CONSERVATION TEAM CONSULTATION APPLICATION RESPONSE

APPLICATION REF:	26/01795/FPH & 26/01796/LBC
CASE OFFICER:	TK
APPLICATION SITE:	46 Ridge Road, Letchworth Garden City, Hertfordshire, SG6 1PN
DESCRIPTION OF WORKS:	Single storey rear extension following demolition of existing lean-to.

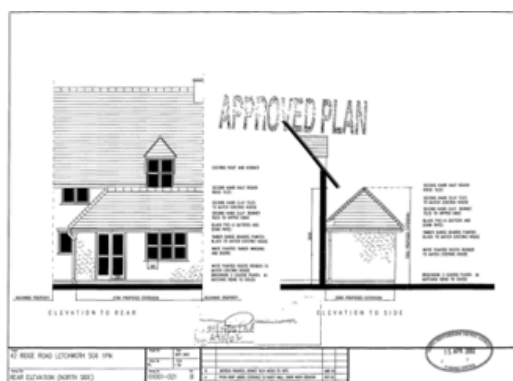
Rear single-storey extensions schemes to the listed, even-numbered properties at Ridge Road, have followed a generally broad format of tiled pitched roofs additions with one exception. The most recent scheme of this type related to no. 27 Birds Hill around the corner where a flat-roof design was negotiated away and consent granted for the right-hand scheme below which has a flat roof light on a section of flat roof.

*The current scheme also seeks a parapet, flat-roofed addition and once again considering the tiled mono-pitch projections to nos. 118 and 122 on either wide and **where there has been a consistent approach to supporting tiled, pitched roof extensions over the years**, I question whether this is appropriate to the character of the host building and the terrace to which this forms part.*

The depth of the extension and position of the staircase window are such that a mono-pitch roof would not be feasible. Furthermore, whilst a hipped, pitched roof as per the image above right is feasible the ridge would extend higher than the existing rear eaves. Having said that, I consider that a rendered parapet as opposed to seeing the edge of the single ply membrane flat roof and timber fascia would possibly have been a preferred detail but once again this would result in an increased height pushing the parapet up to the sill of the first-floor window. Therefore, I am not encouraging this alternative. However, I question the rainwater goods / dispersal and the fascia board material, hence conditions below.
